# UNITED STATES PATENT AND TRADEMARK OFFICE

<b>Office Action Summary</b>	<b>Application No.</b> 10/526,444	<b>Applicant(s)</b> STEIN ET AL.	
	<b>Examiner</b> DNYANESH KASTURE	<b>Art Unit</b> 3746

## **DETAILED ACTION**

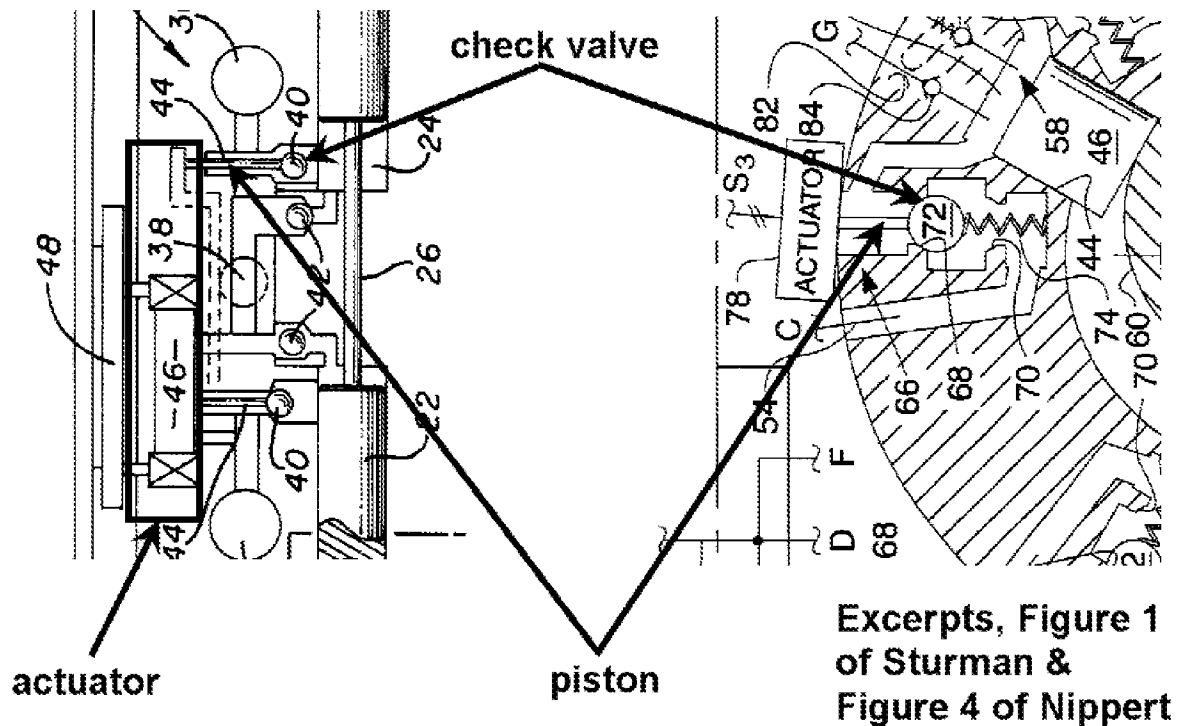
80. Applicant has argued that Sturman incorporates by reference Patent 5640987 which discloses a valve that is allegedly too slow to operate and would be allegedly inappropriate for partial modes. Applicant further alleges that the piston (44) of Sturman is incapable to open valve (40) against pressure in the chamber.

81. Examiner’s Response: MPEP 2145, Section IV states: One cannot show nonobviousness by attacking references individually where the rejections are based on combinations of references. In re Keller, 642 F.2d 413, 208 USPQ 871 (CCPA 1981); In re Merck & Co., Inc., 800 F.2d 1091, 231 USPQ 375 (Fed. Cir. 1986). Even if the control valve actuator (46) of Sturman is too slow or unable to open valve (40) against

the pressure of the chamber, the actuator (76, 78) of Nippert clearly is capable of these functions (partial pumping mode described on Page 8, Lines 26-35). It is only a matter of routine skill to choose an appropriate actuator to suitably perform the desired valve opening function, and achieving this objective is only a matter of replacing the actuator (46) of Sturman with the actuator (76 or 78) of Nippert. Note that exit pressure is being supplied to the piston (44) of Sturman for the sole purpose of actuating the piston. The figure below shows the equivalent elements of Sturman and Nippert:
